Access Compliance Report

Public Rights-of-Way

Intersection ID: 12551	Main Street: BELVEDERE_AV	Cross Street: CLUB_RD	Location: SE
ADA ID: 0B25F975F13A	Ramp Type: PerpDiag	Initial Pass/Fail: Fail	Overall Compliance: No
		Severity Score: 10

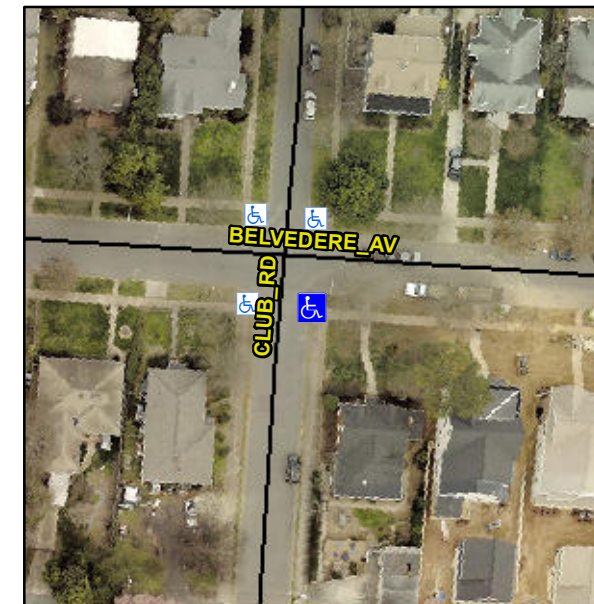
Not Found, R304.5.1, R304.5.3

Compliance	Description	Data	Compliance	Description	Data
N/A	Ramp Length (in)	56.0	Yes	Ramp Slope (%)	6.8
No	Ramp Width (in)	38.0	No	Ramp XSlope (%)	2.8
N/A	Flare Type LT	N/A	N/A	Flare Type RT	N/A
N/A	Flare Slope LT (%)	N/A	N/A	Flare Slope RT (%)	N/A
N/A	Flare Traversable LT?	N/A	N/A	Flare Traversable RT?	N/A
N/A	Landing Length (in)	N/A	N/A	DWS Provided?	N/A
N/A	Landing Width (in)	N/A	N/A	DWS Contrast?	N/A
N/A	Landing Slope (%)	N/A	N/A	DWS Length (in)	N/A
N/A	Landing X Slope (%)	N/A	N/A	DWS Full Width?	N/A
N/A	Landing Curb? (Y/N)	N/A	N/A	DWS Offset (in)	N/A
N/A	Shared Landing?	N/A			
N/A	Gutter Ponding?	N/A	N/A	Gutter Slope (%)	N/A
N/A	Gutter Lip Ht (in)	N/A	N/A	Gutter X Slope (%)	N/A
N/A	Painted X Walk1?	No	N/A	Painted X Walk2?	No
	X Walk 1 Direction	To N		X Walk 2 Direction	To W
N/A	X Walk 1 Width (in)	N/A	N/A	X Walk 2 Width (in)	N/A
	X Walk 1 Slope (%)	1.0		X Walk 2 Slope (%)	5.9
	X Walk 1 X Slope (%)	4.9		X Walk 2 X Slope (%)	1.7

Remove & Replace Curb Ramp With Two New Directional Ramps or Equivalent.
